SERVICE BULLETIN

TAIL ROTOR GEARBOX ATTACHING BOLTS, ONE TIME INSPECTION

369D/E/F/FF helicopters with Yehnert modified tailbooms (p/n YH-228) installed per STC SH5055NM.

Figure 1 - Inspection Location

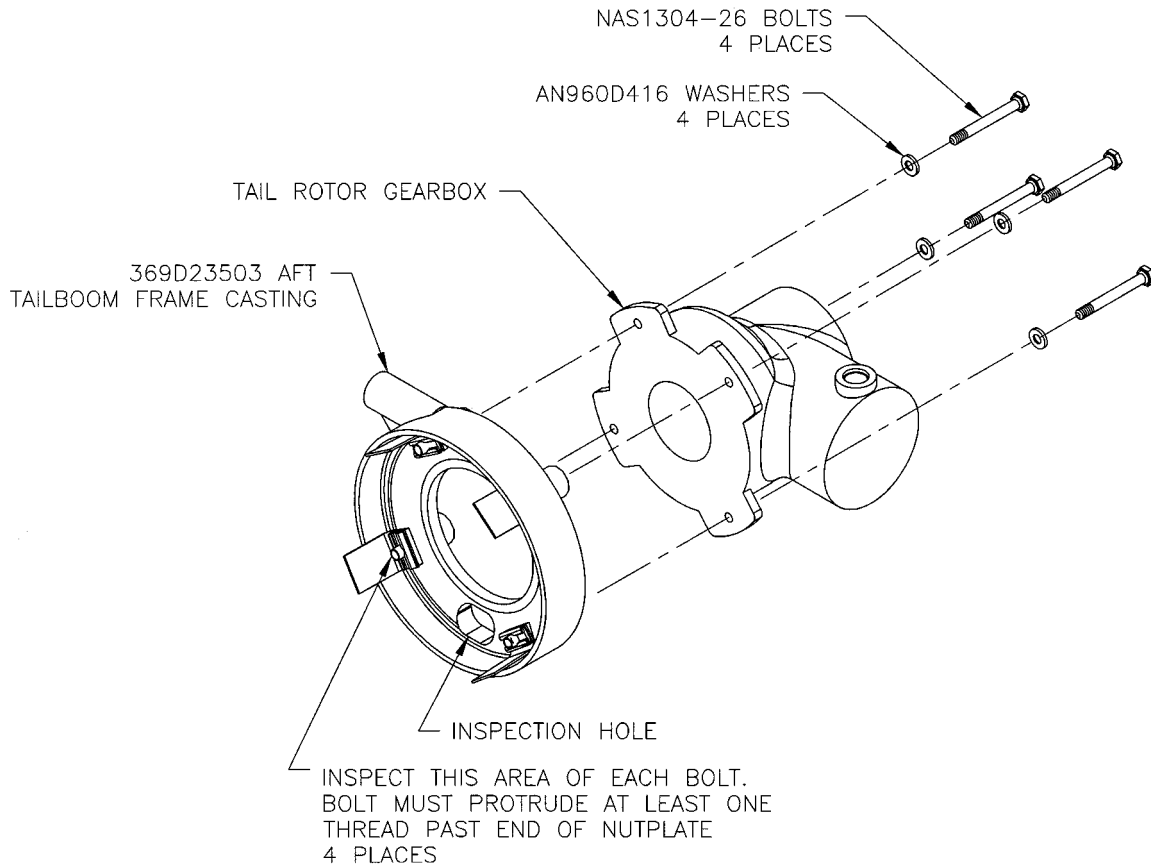
5. Insert the mirror or borescope into the aft section of the tailboom.
6. Inspect the nutplates on the internal surface of the aft tailboom frame casting, p/n 369D23503 as shown in *Figure 1*.

7. Check the number of threads protruding out of the nutplate for each of the four gearbox to tailboom attachment bolts. One to four threads should protrude. If more than four threads protrude, use one additional AN960D416 washer.
